HATFIELD BOROUGH PLANNING COMMISSION

PLANNING COMMISSION December 16, 2024 6:00PM AGENDA

**23 North Main Hatfield
Walk Land Development
Plans and
Turning Template**

**Response Letter to Review
Letter from Bursich
9.18.24**

POST AND RAIL FENCE

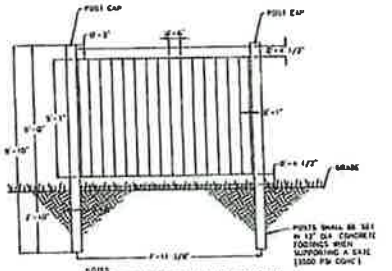
Response: The existing parking easement/ lease area has been provided on the plans.
2. The existing pull-in parking spaces for the Post Office are located approximately 8 feet from the proposed Community Area and underground storm basin. A barrier should be installed to stop vehicles from driving into this area.

Response: A post and rail fence has been added to the plans.
3. The intention of the Community Area and any amenities shall be clarified.
Response: The community area is to be kept as lawn. A label has been added to the plans.

Drawing No.
C6.0

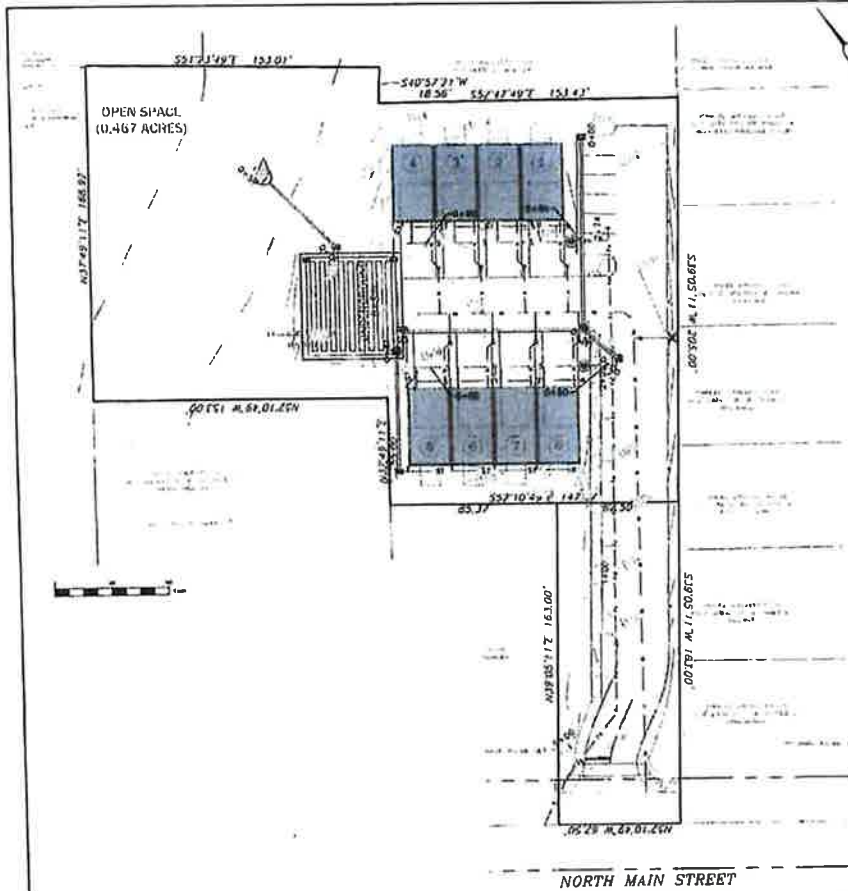
1. The proposed silt socks must be shown more clearly on sheet 10.

2. Existing trees and Tree Protection Fencing must be added to the plan.

Response: On Plan Sheet C5.0, the filter socks are now shown more clearly.

Response: On Plan Sheet C5.0, the existing tree line, the proposed tree line and tree protection fencing has been added.

PROFILES

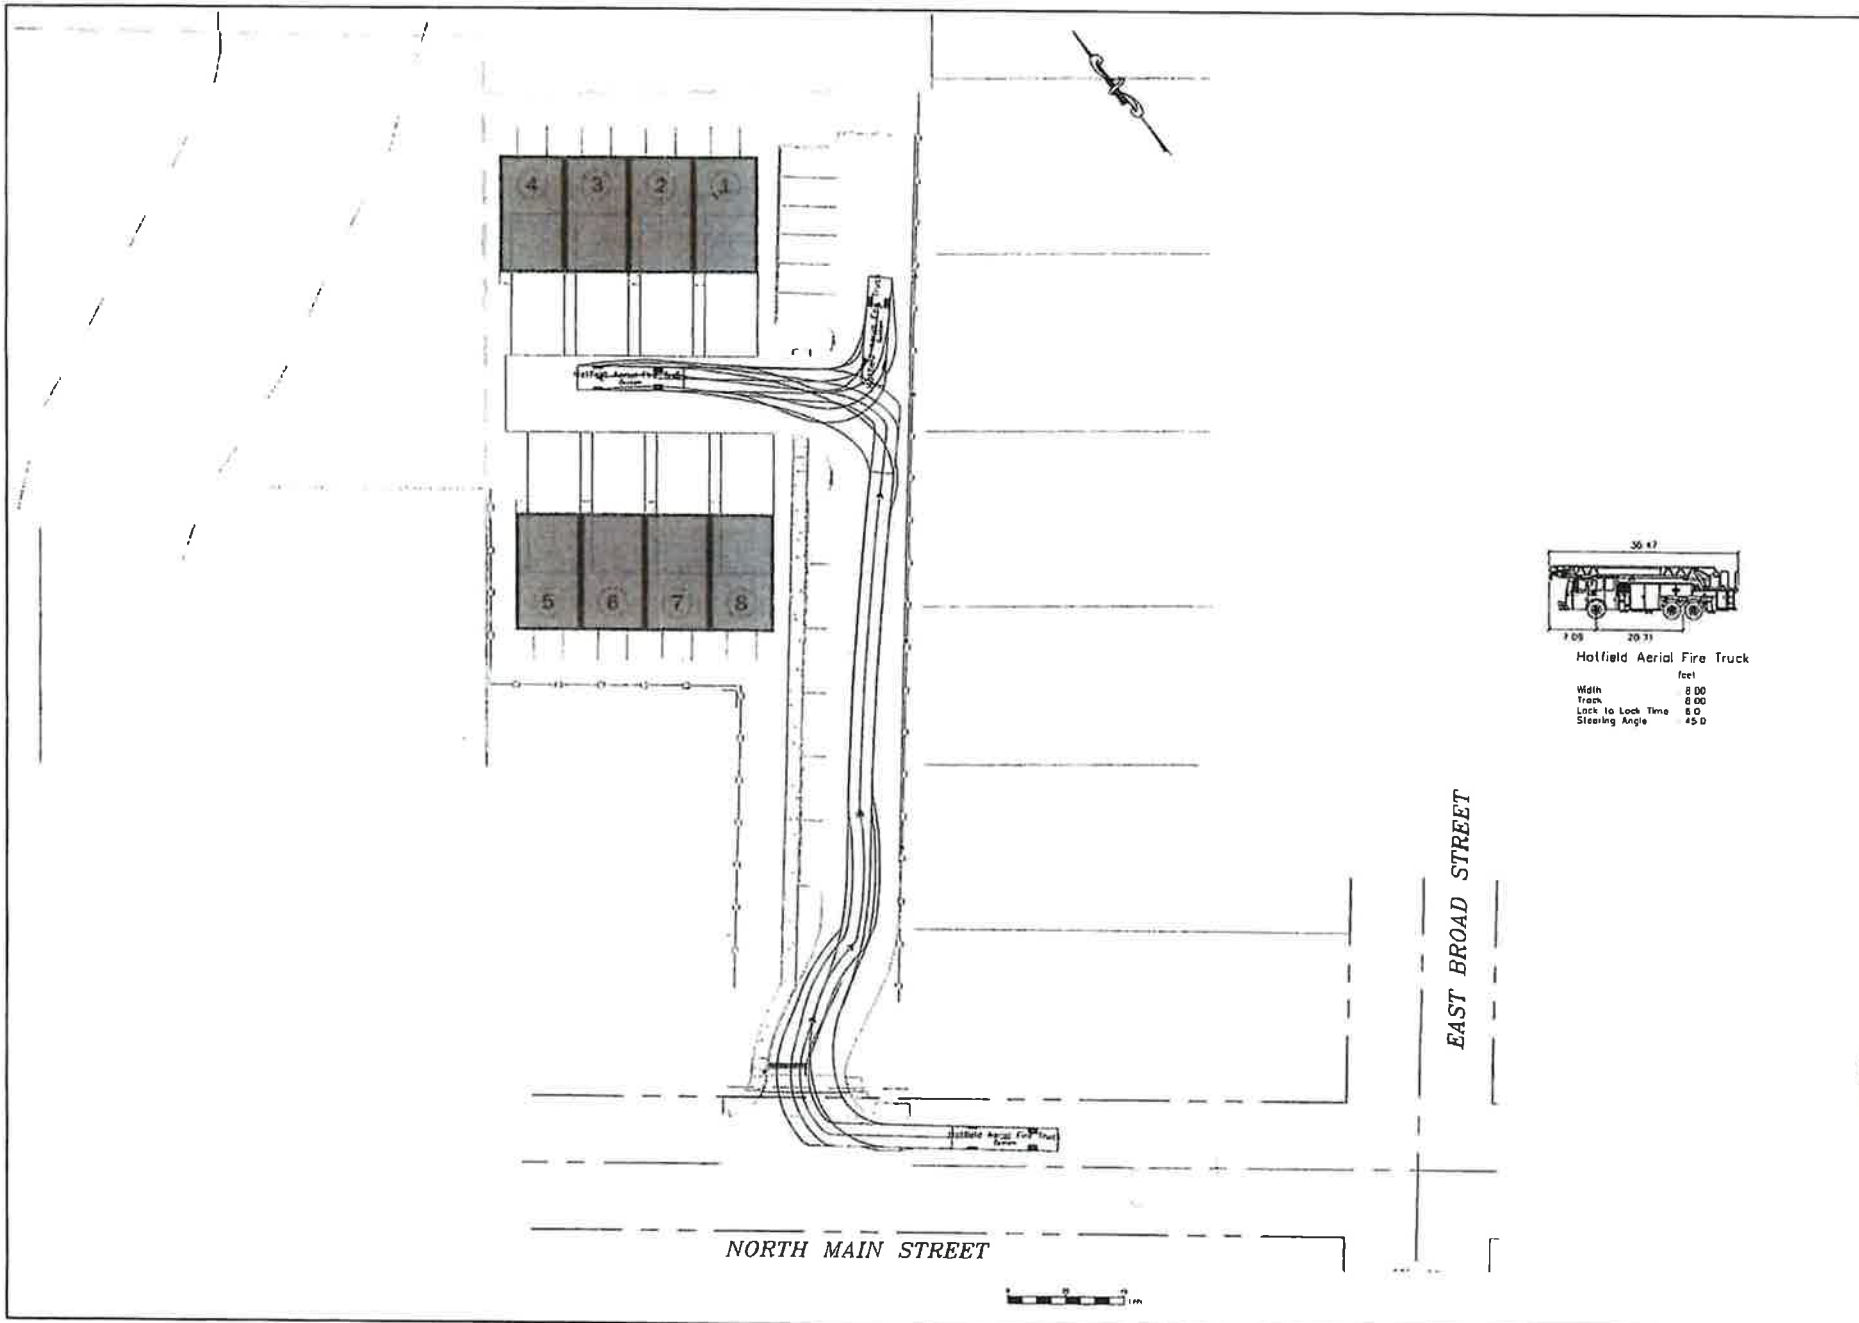
- Q. The proposed grades shall be shown on the plan view on sheet 14.

Response: Grades have been added to the profile sheet.
